ADDENDUM #1
BL097-26, Bethesda Park Aquatic Center Wall Tile and Floor Replacement

QUESTIONS & ANSWERS:

SHEET NUMBER
A6.1

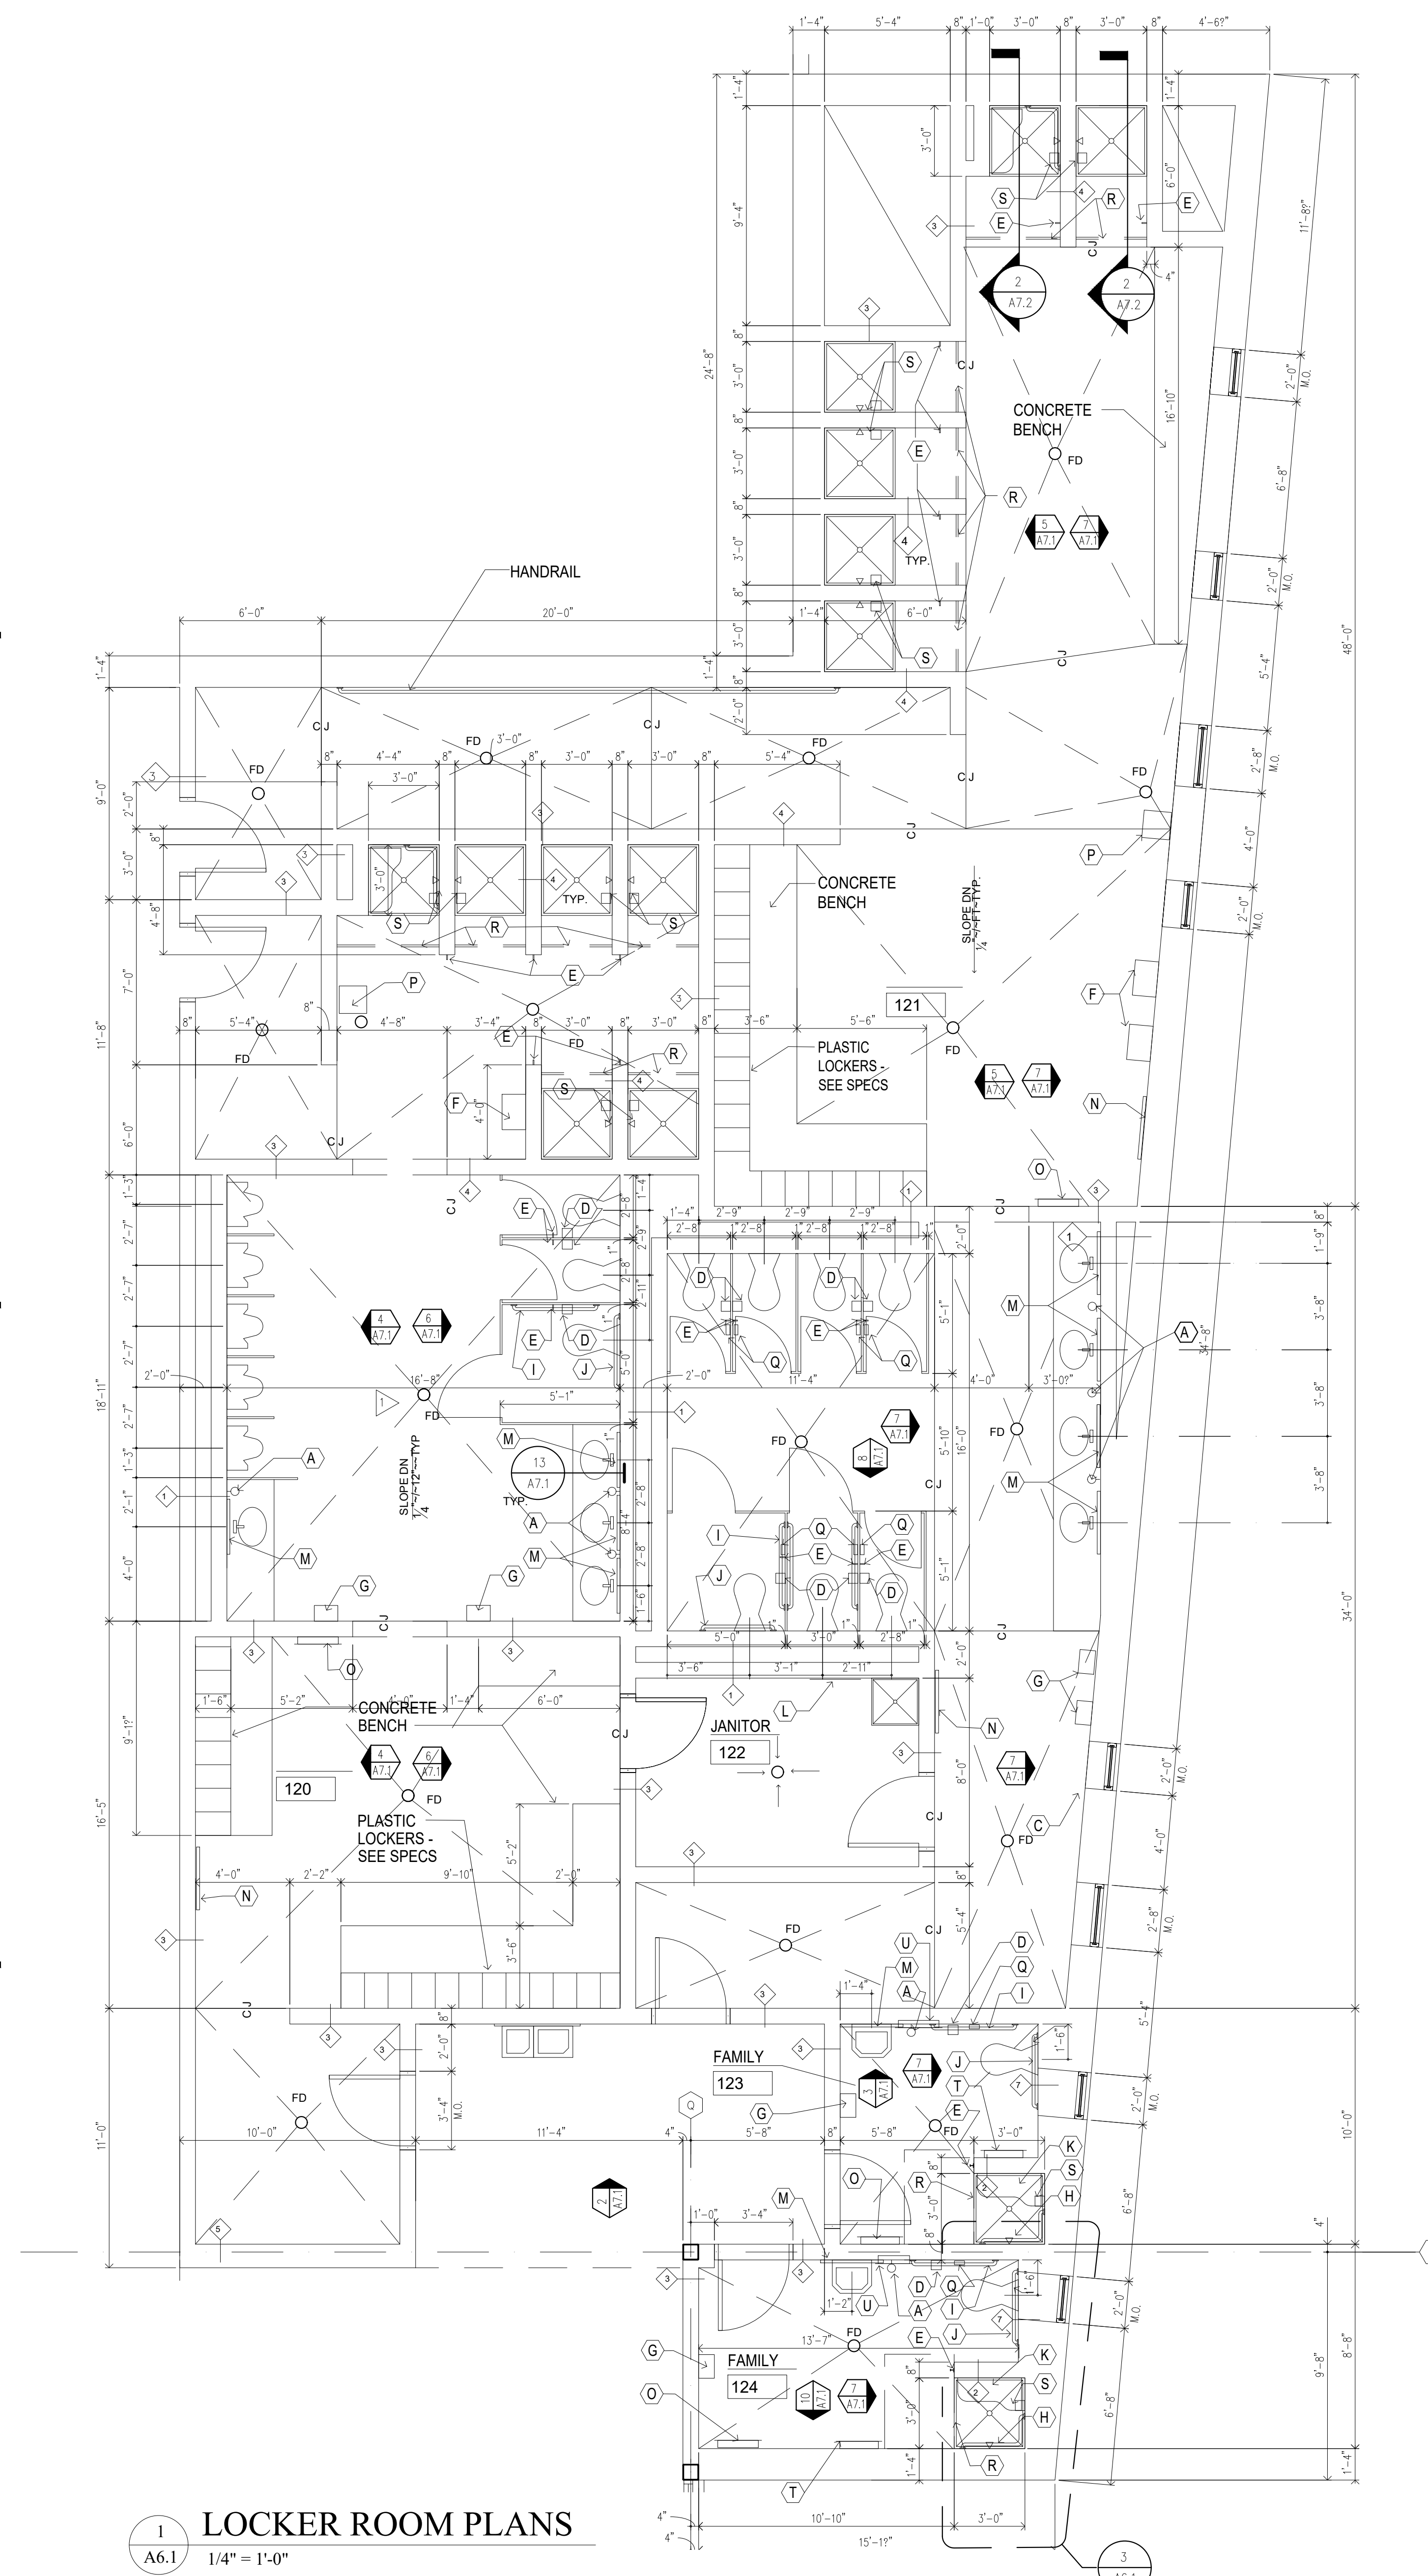
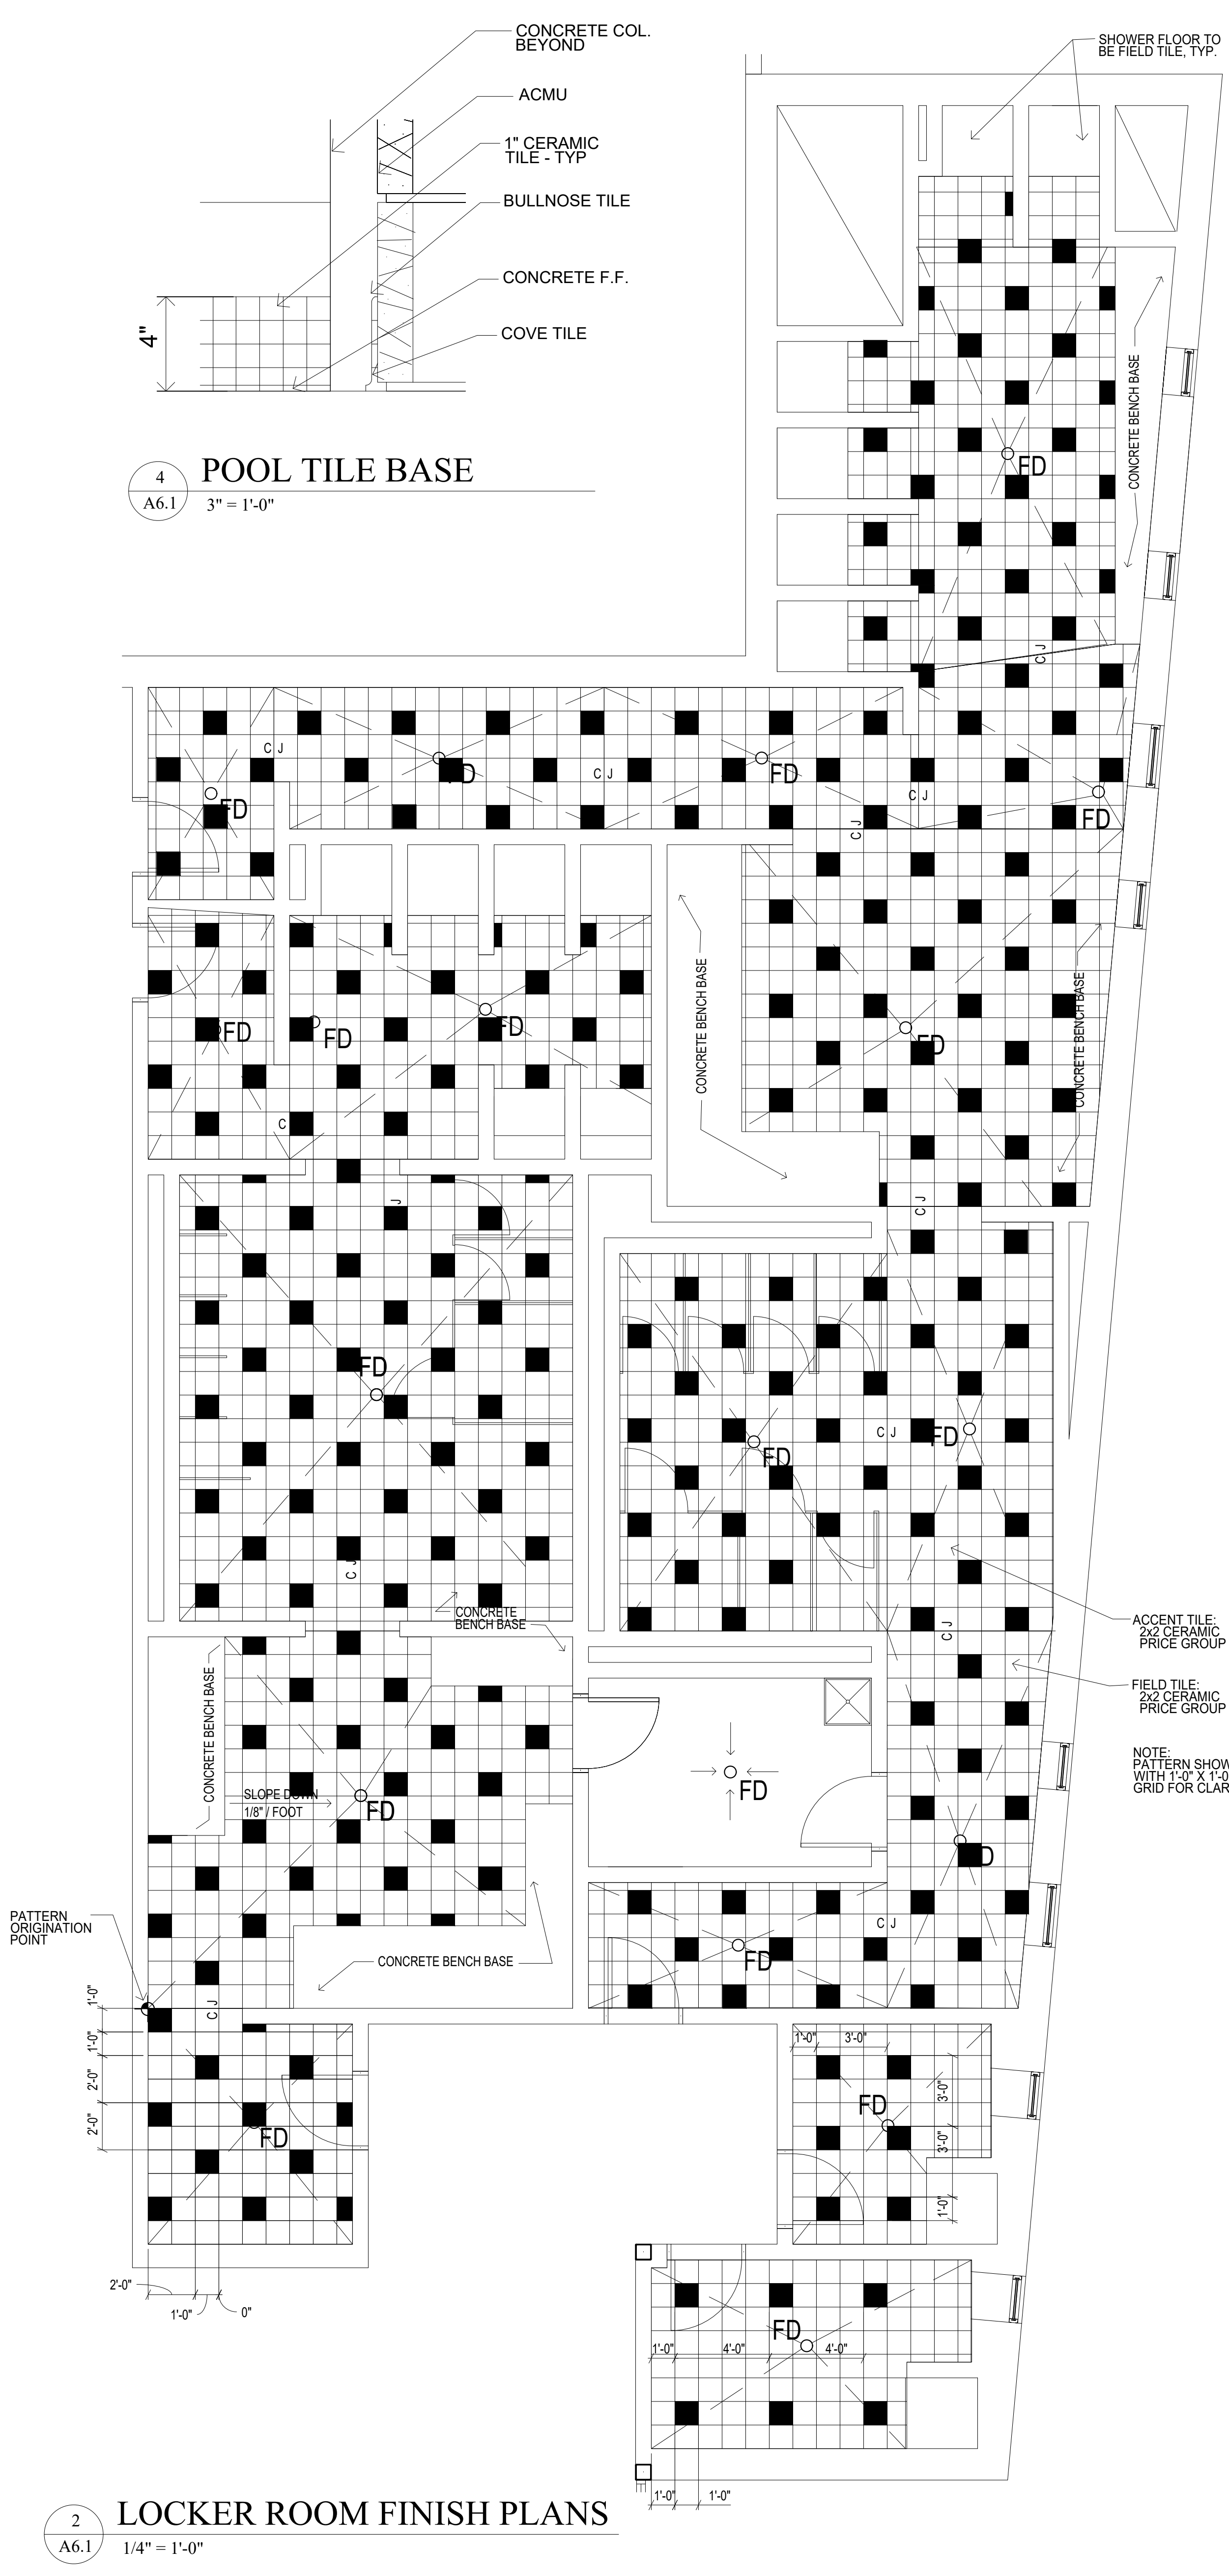
- A5. If additional time is needed, the County and the awarded contractor shall coordinate an appropriate schedule.
- Q6. Could you please provide the total square footage or project dimensions of the areas to be completed? I need the project specifications to accurately calculate materials, labor and submit a bid. If available, I'd also appreciate any plans or drawings showing the measurements.**

- A6. Floor plans for the locker rooms and restrooms are attached. Contractors are responsible for taking accurate measurements and verifying field conditions.
